Comhairle Chontae Atha Cliath Theas

Record of Executive Business and Chief Executive's Order

Reg. Reference: SDZ22A/0018

Submission Type: Additional
Information

Figure 1- Overall Street layout proposed

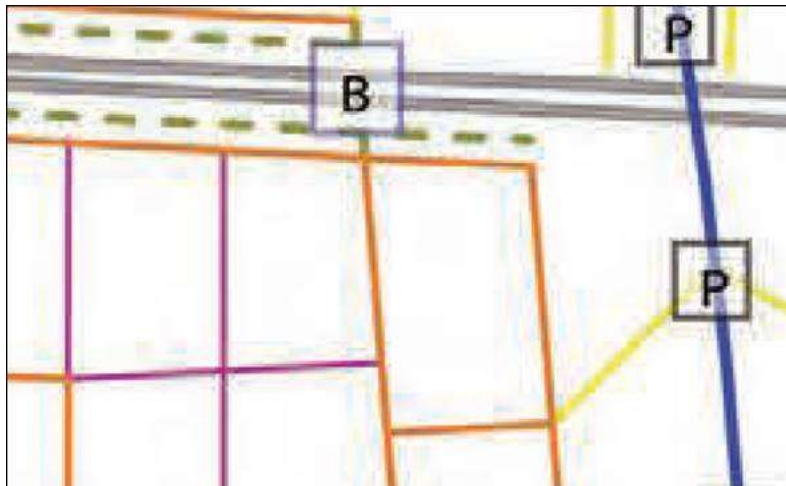
1. *“Homezones South and West of Block G:
This section of homezone should continue to the South Western corner of Block G before continuing along the West of Block G. The SDZ designates this street as a Homezone, but the proposal is to make this a Local Street (Fig. 3). No justification has been given for this deviation.*
2. *North/South Pedestrian/Cyclist Route:
This pedestrian/cyclist route is not included in the SDZ plan. It is, however, a welcome addition which provides a pedestrian/cyclist connection onto the Southern Link Street via a filter junction. The SDZ designates a Local Street to the West of the Public Square. This has been replaced in the application by a pedestrian/cyclist route. This is considered a necessary deviation as it is required to match the junction locations the Southern Link Street (SDZ20A/0021)”.*

Figure 2.2.6 Example Local Streets including Homezones (Intimate Scale)

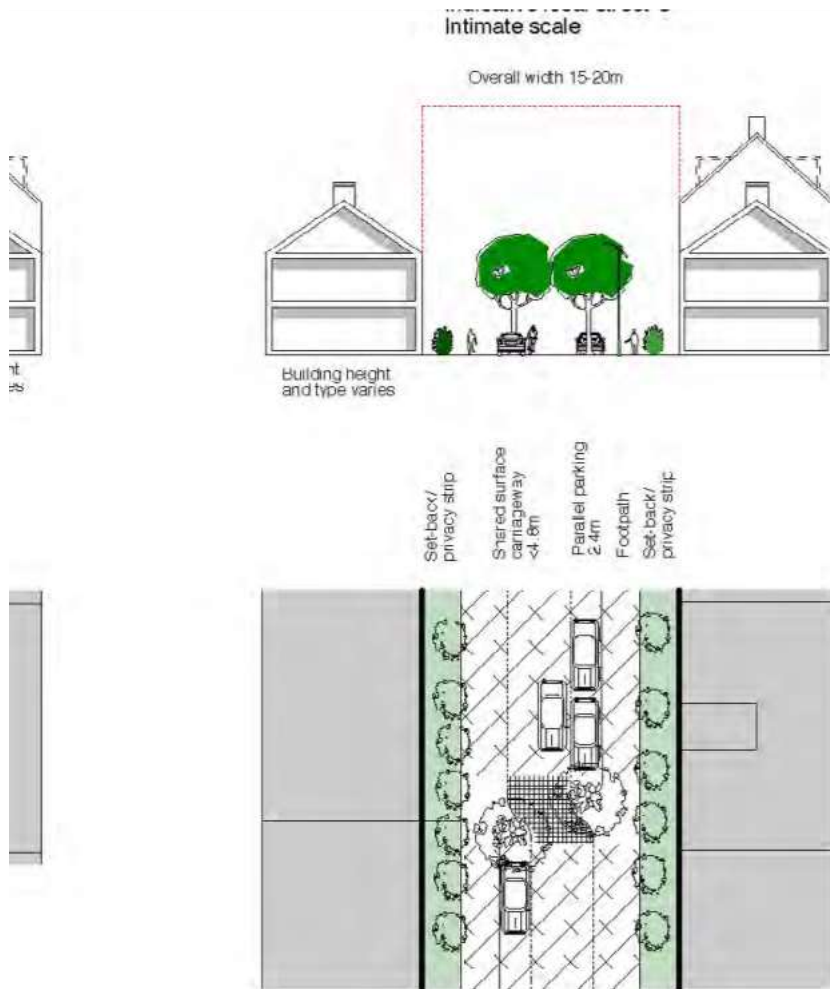
The applicant is requested to provide a clear layout plan indicating:

- The road typology
- Width between building frontages (including areas with planning permission or under consideration applications)
- Carriageway width
- Footpath width
- Privacy strip width (if present)
- Location of street trees.

Additional information is requested.
